Response to Castle Adequacy Review Response #3

Memo

Re: Continental Materials Corporation/Castle Aggregate, Pikeview Quarry, Permit M-1977-211, Amendment 04, Review of February 7, 2020 Operator Adequacy Answer to DRMS Third Adequacy Review and DRMS Fourth Adequacy Review.

Figure 1. From Google Earth aerial photo of June 6, 2018 showing informal upland drainage ditch breached in approximately 2015 and still not repaired as of 2018. Above west quarry highwall, north side.

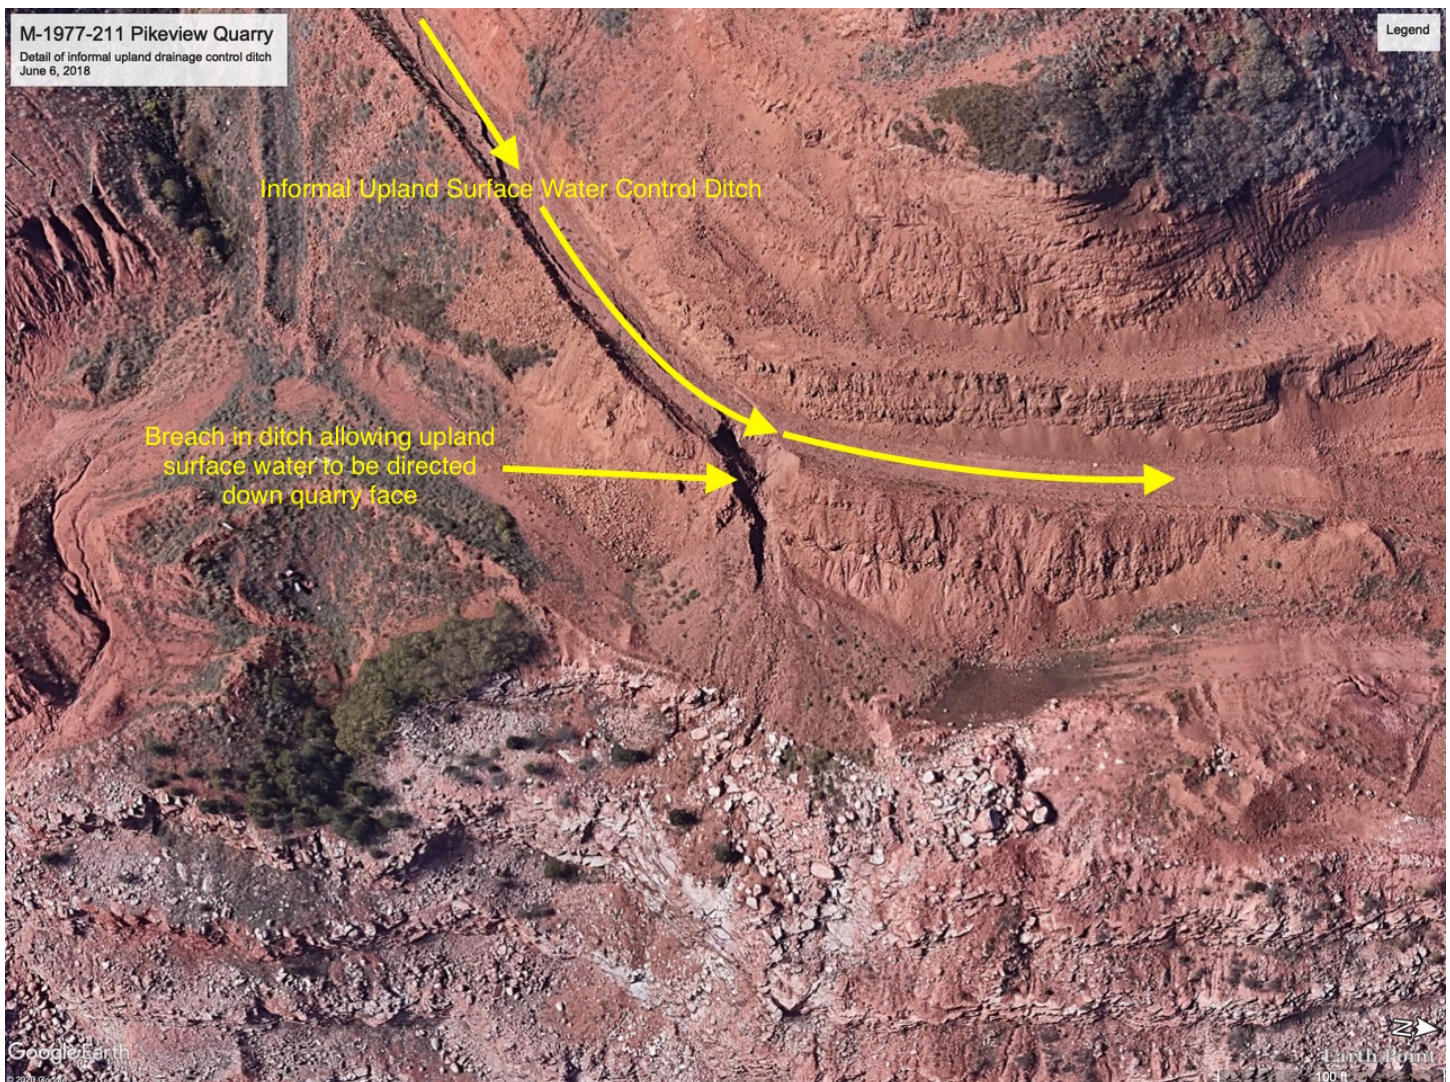
The failure of the northern diversion is what caused water to cascade down the quarry wall in 2015. This ditch looks like it is still not repaired as of 2018 (see Figure 1). It is now obvious that this approach leads to consistent failure of the upland diversion ditches. Why is DRMS not requiring designs for this structure at this point and requirements that the structure be built to those designs?

Figure 4 – Pikeview Quarry – Detail of conchoidal fractures in the south part of the West Highwall, 2018.

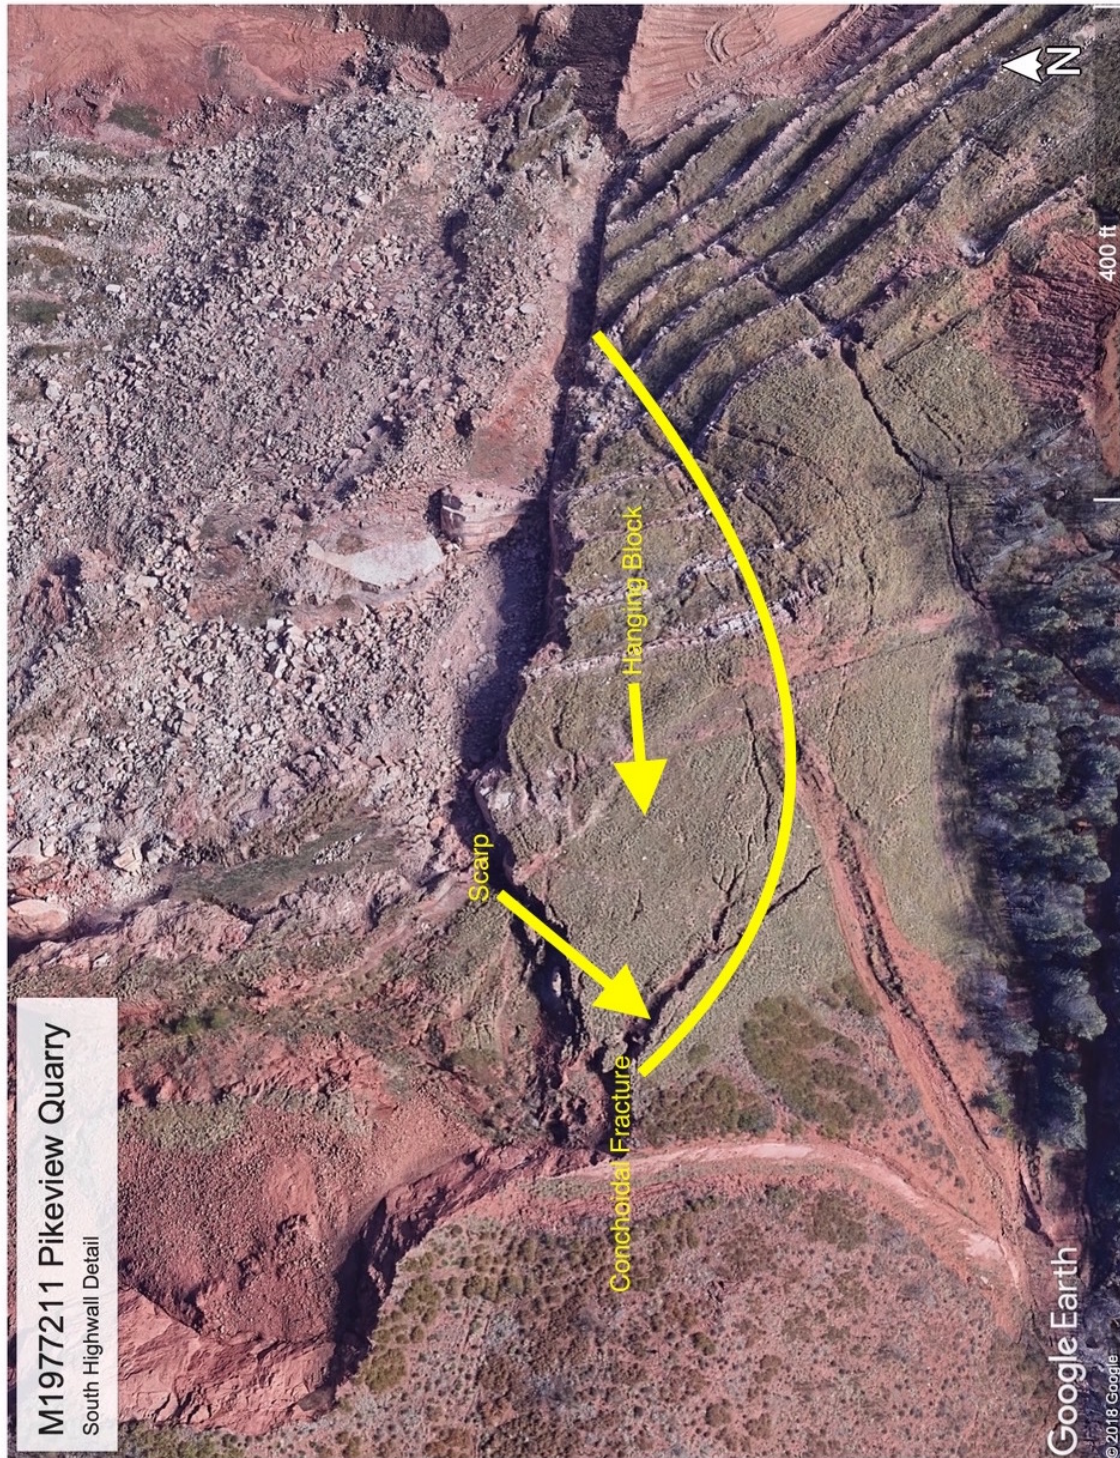
Aerial photos of 2017 (Figure 2) and 2018 (Figure 3 - whole quarry; Figures 4 and 5 - detail) indicate a scarp above the southernmost hanging block at the top of the highwall. The Sawatch clay layer underlies the hanging block located on the south side of the western highwall. Exponent deemed the clay layer the primary failure cause for the December 2, 2008 and related slides. In other words, we are not talking about safety factors of unconsolidated materials such as exist in the body of already failed material but a special condition of a clay layer in the upper part of the Sawatch Formation that could lead to sudden and unexpected sliding of now hanging material above that layer now that the buttressing blocks of material below this have already failed and slid downslope. An additional complicating and destabilizing factor is that the scarp and the separation of materials at the top of the block will probably allow additional surface water to flow directly to the clay layer and further lubricate and destabilize this block.

Figure 6 – From Exponent Report (2011), Appendix 39. Map of Pikeview Quarry showing Cross Section Locations including G-G'.

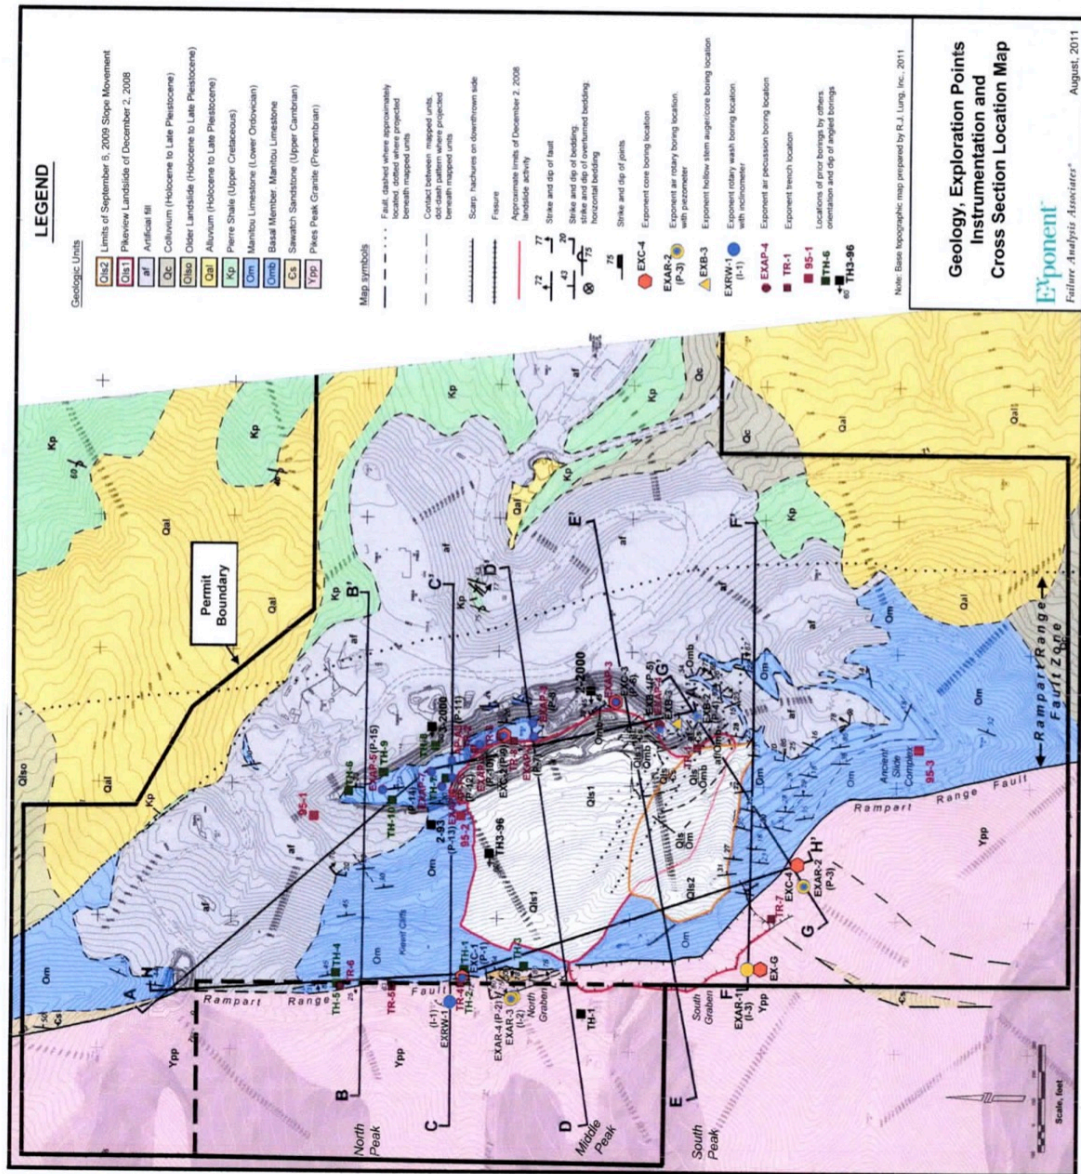
The Exponent Report of 2011 includes a cross-section in Appendix 39 (G-G') that is indeed drawn along the slope gradient and probably intersects part of the present hanging block of limestone in the southern part of the west highwall of the quarry (Figures 6 and 7). After reading this part of the Exponent Report, the concern of instability of this rather large block of material only grows larger because it clearly shows that this is a hanging block and the block could slide in the near future if not properly buttressed, avoided, or handled in some other appropriate way. CMC and DRMS need to recognize this to protect worker safety and address this concern.
